Project Code & Schematics Subject:

H800 Main Board1P-0099L00-A000 (COMPEQ)  
1P-0099J00-A000 (IRIS)

Title			
ST Changelist			
Size	Document Number		Rev
A2	H800 MB		X-Build
Date:		Wednesday, October 07, 2009	
Sheet		48	of 50

File		
X-Build Changelist		
Size	Document Number	Rev
A2	H800 MB	X-Build
Date: Monday, October 12, 2009 Sheet 50 of 50

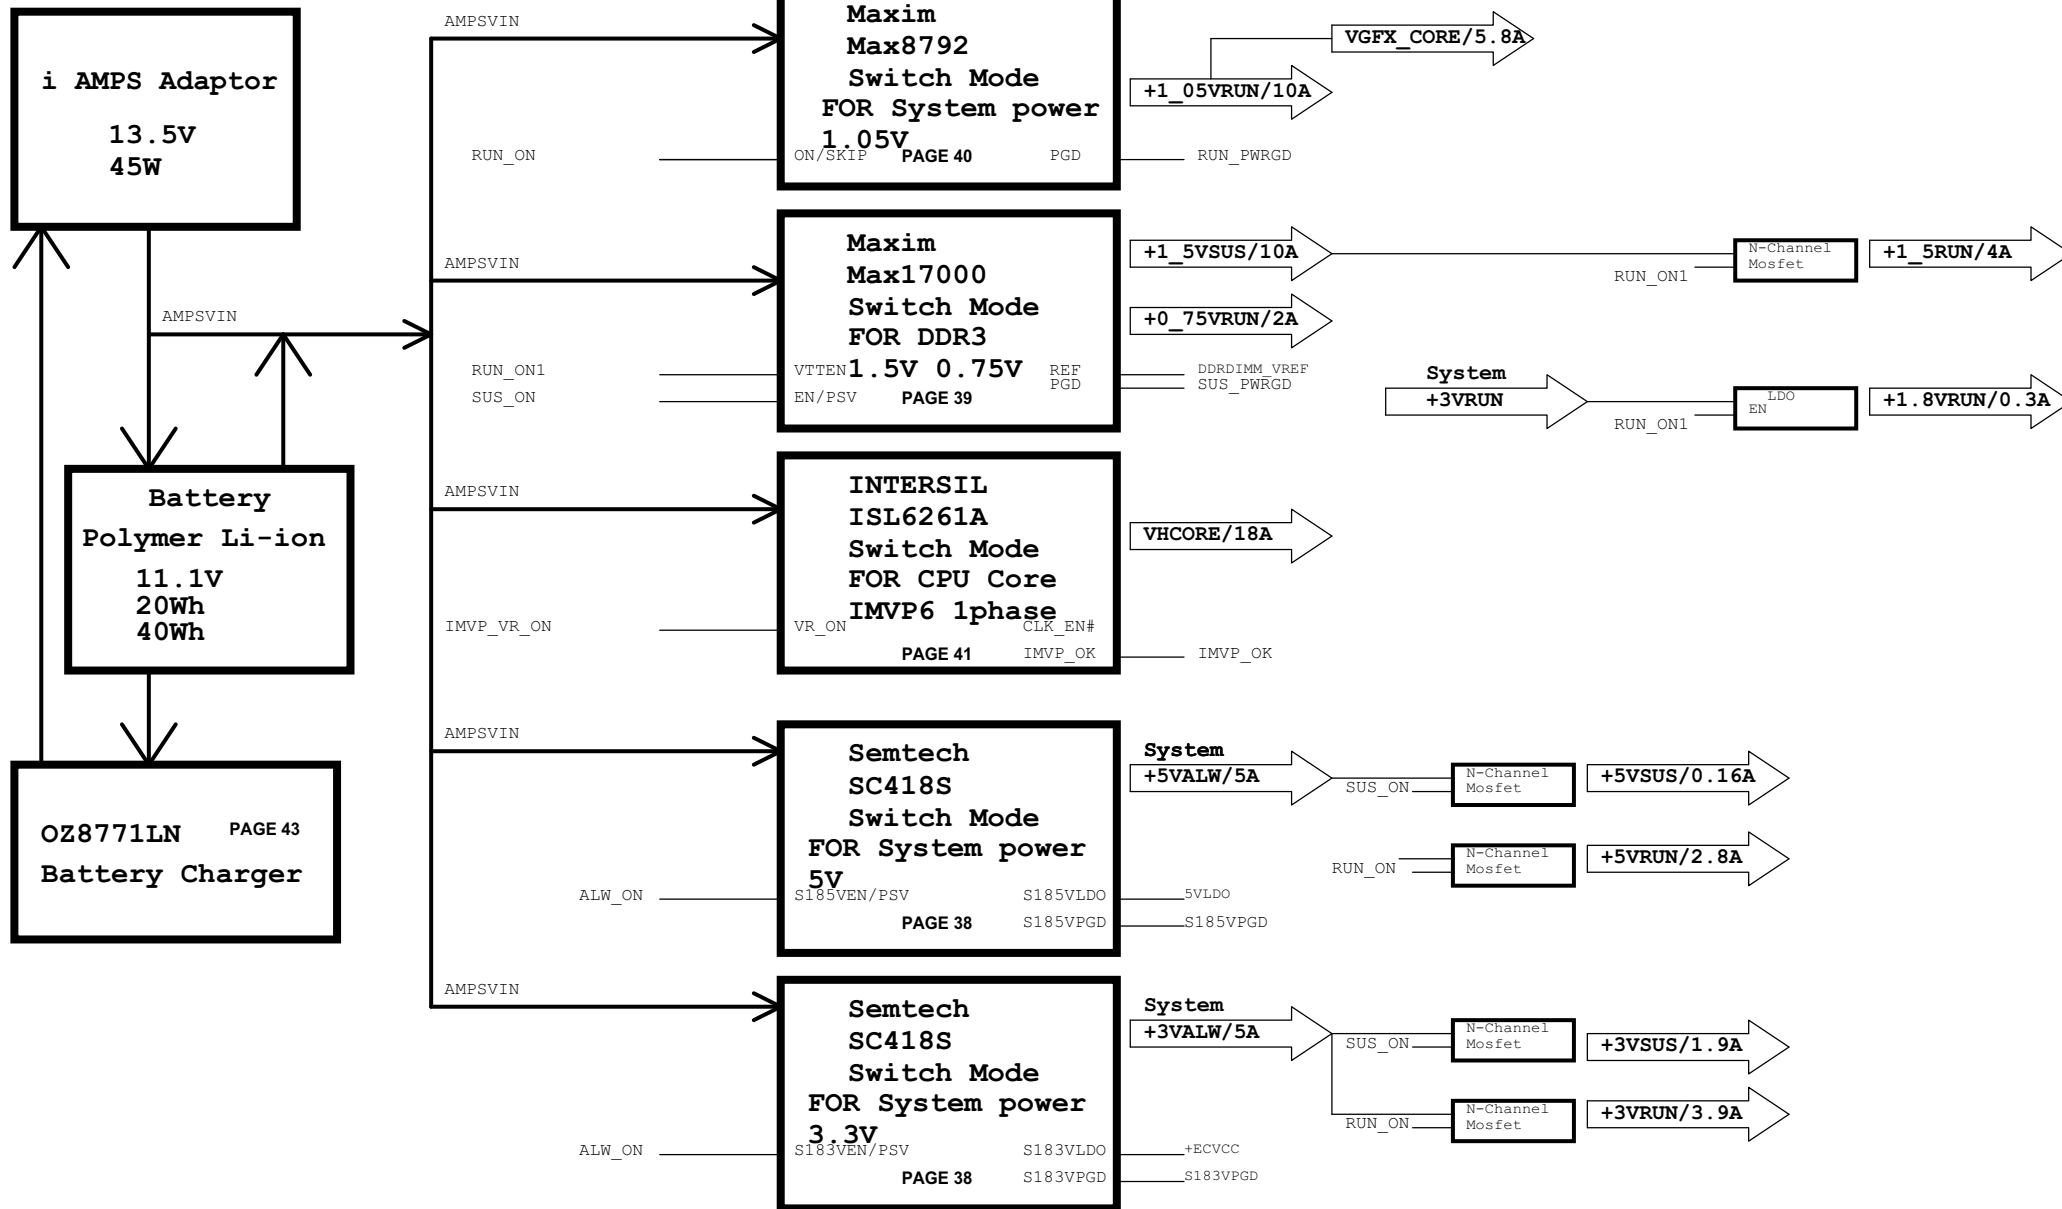
**PT2 2009.05.04**  
 Added RP55 & RP54 for the path select function.  
 If RP55 Mount / RP54 NC : PWM control function by EC.  
 If RP55 NC / RP54 Mount : I2C Bus connection between Cypress uC(Latch FPC) & EC.
